INTER-OFFICE CORRESPONDENCE

SUBJECT: **Administrative Site Plan Review – §6.3.14 and §7.5.**
Family Aid Boston, Inc. - Applicant
“Family Navigation Center”
1650 Washington Street

ZONING REVIEW MEMORANDUM
Administrative Site Plan Review

Re: Administrative Site Plan Review – 1650 Washington Street

North Exterior Elevation

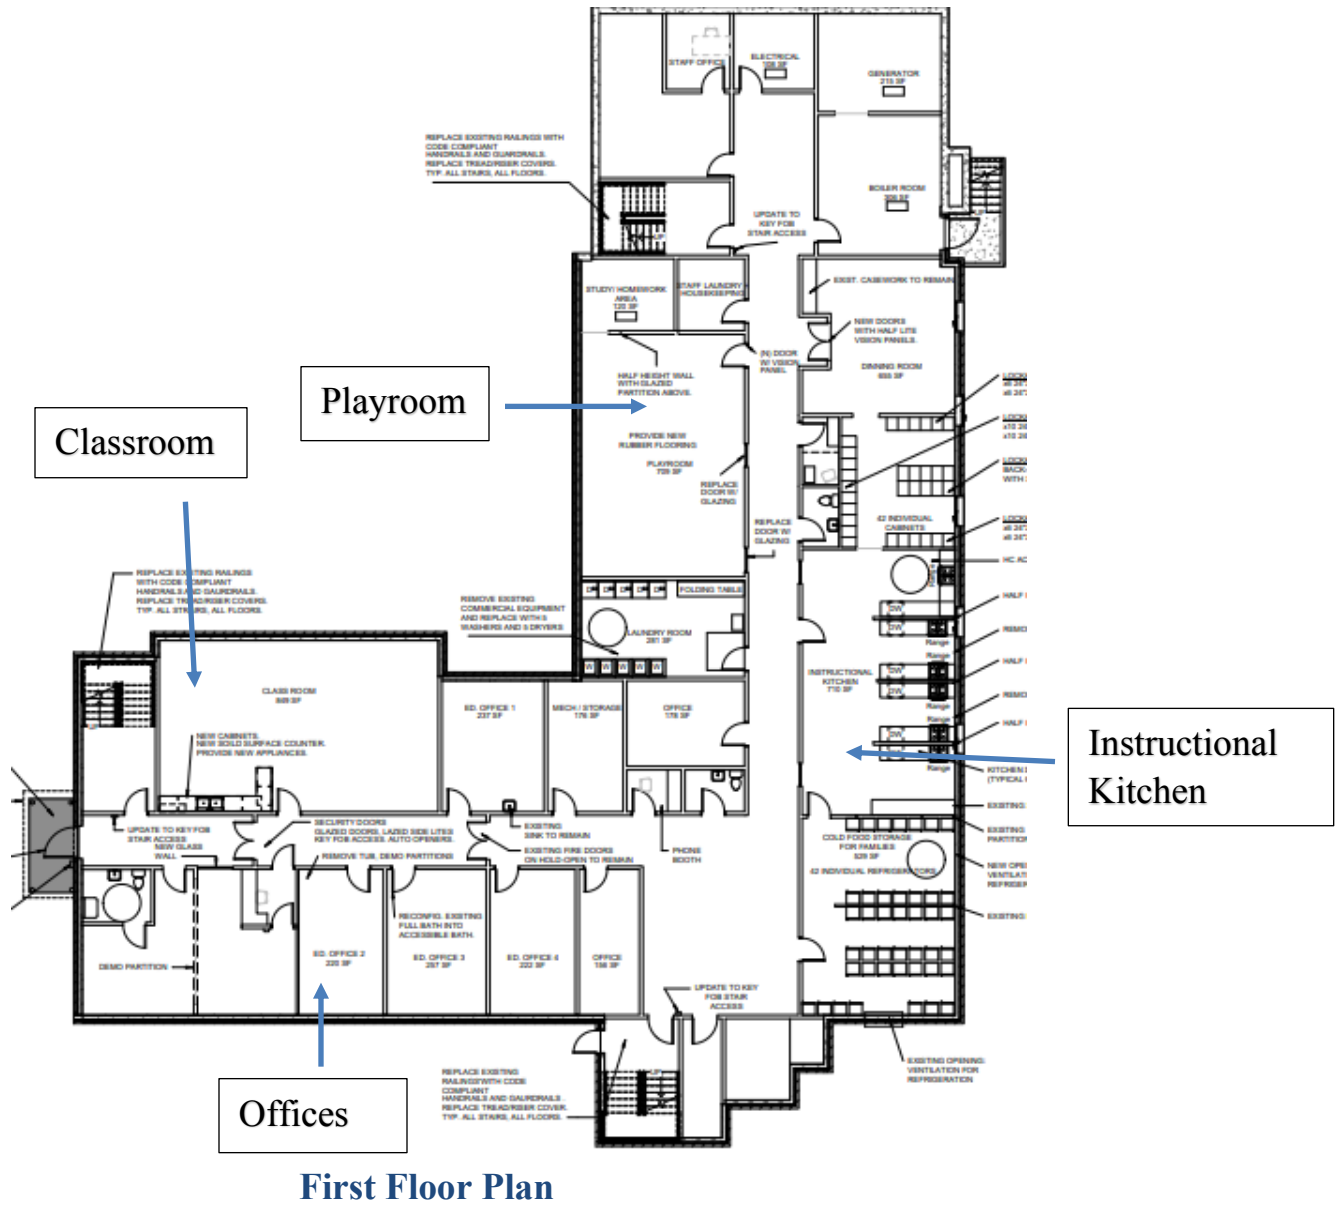
The exterior of the building will be maintained as it currently exists (see north elevation below). The primary change will be that the main entrance to the building will be relocated from the above grade entrance at the north side of building fronting Washington Street, accessible only by stairs, to an existing side entrance of the building. According to the applicant, the primary entrance for families and staff would be the side entrance facing north. Visitors requiring ADA access would utilize the side entrance facing west toward the bike racks.

First Floor Plan

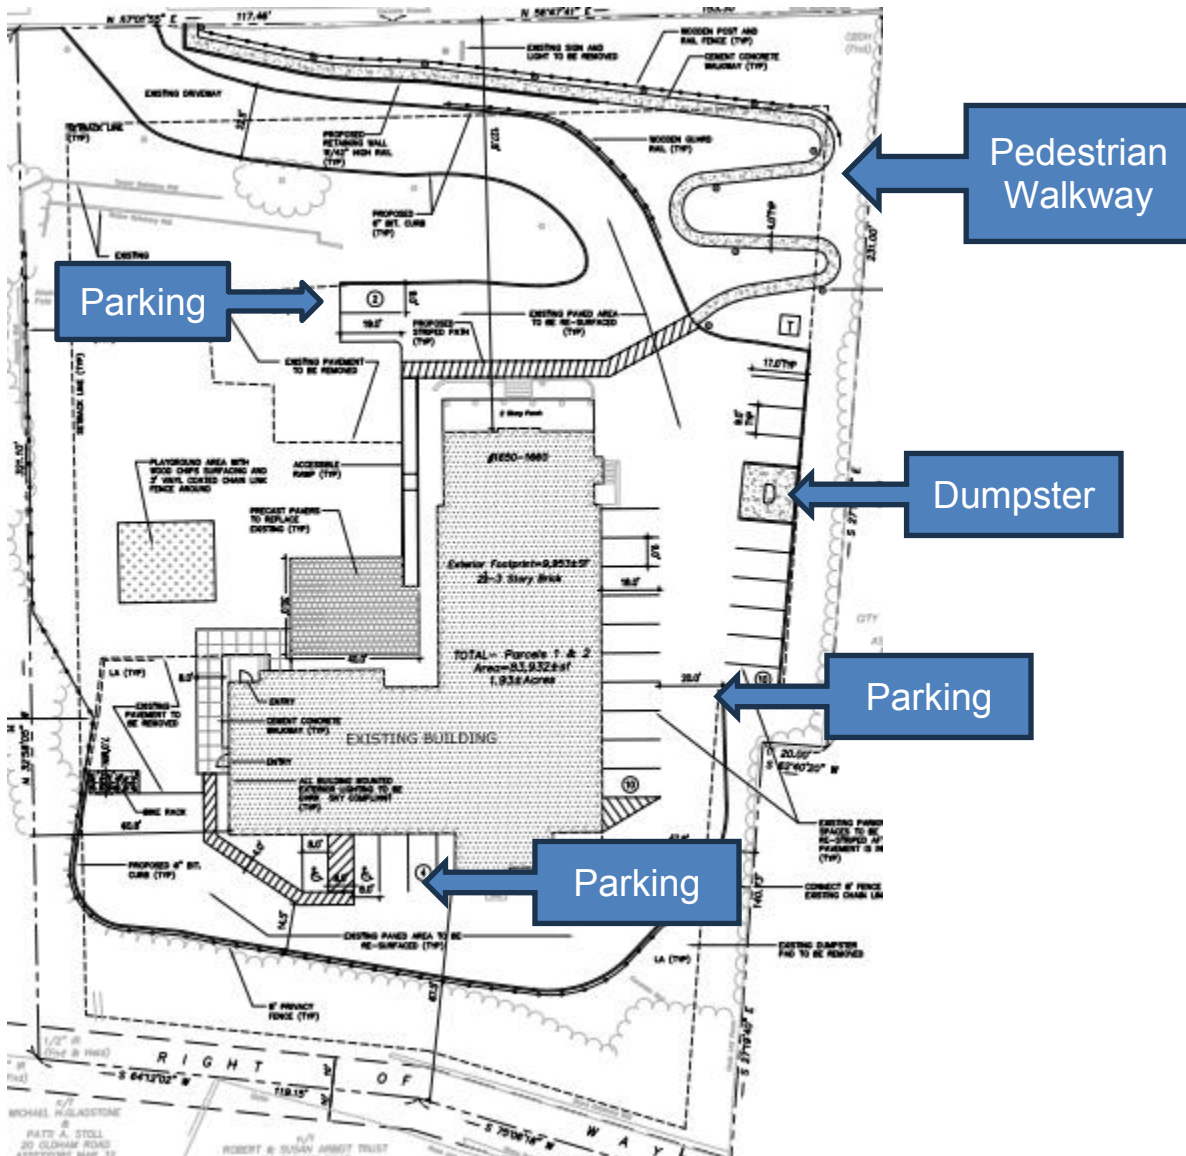
There will be an internal reorganization of the existing internal first floor spaces to accommodate new classroom and play spaces. The project will also involve minor site improvements, including parking repaving and restriping, installation of perimeter fencing, stormwater infrastructure, landscaping and playground installation, and pedestrian walkway improvements. Please refer to the plan below for further details on the first-floor plan.

Proposed Parking Layout

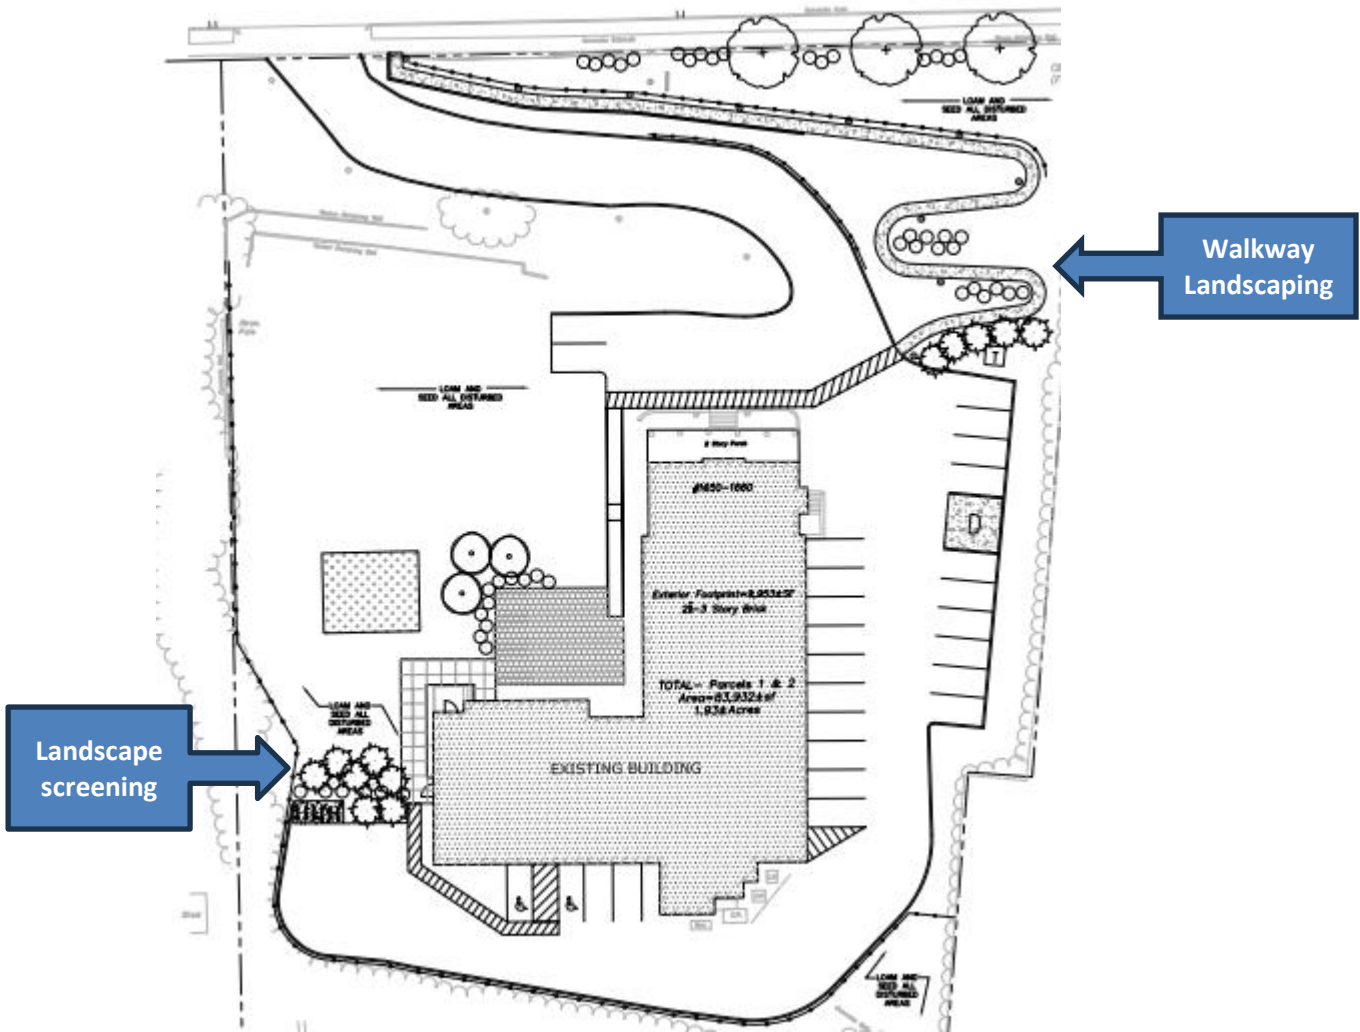
The proposed layout of the improved parking facilities meet most, but not all, the design and dimensional control requirements under Section 5.1. According to the project site plan, the proposed parking facilities do not comply with maneuvering aisle width minimum. There is an existing nonconforming maneuvering aisle width at the rear drive aisle of the property of approximately 15.5 feet where 24 feet is required per Section 5.1.8.C. The new configuration of the rear parking (reducing the number of stalls from six to four) reduces this existing nonconformity, resulting in a greater maneuvering aisle width of 18.5 feet (instead of the existing 15.5 feet-width). As the parking area is being modified, a Dover waiver in lieu of a special permit per section 5.1.13 is required.

The Planning Department believes the proposed parking lot design improves an existing parking facility and complies with most design and dimensional controls and increases the

maneuvering aisle width although still nonconforming. The Planning Department is not concerned with the requested waiver for maneuvering aisle width as it does not pose a safety issue.
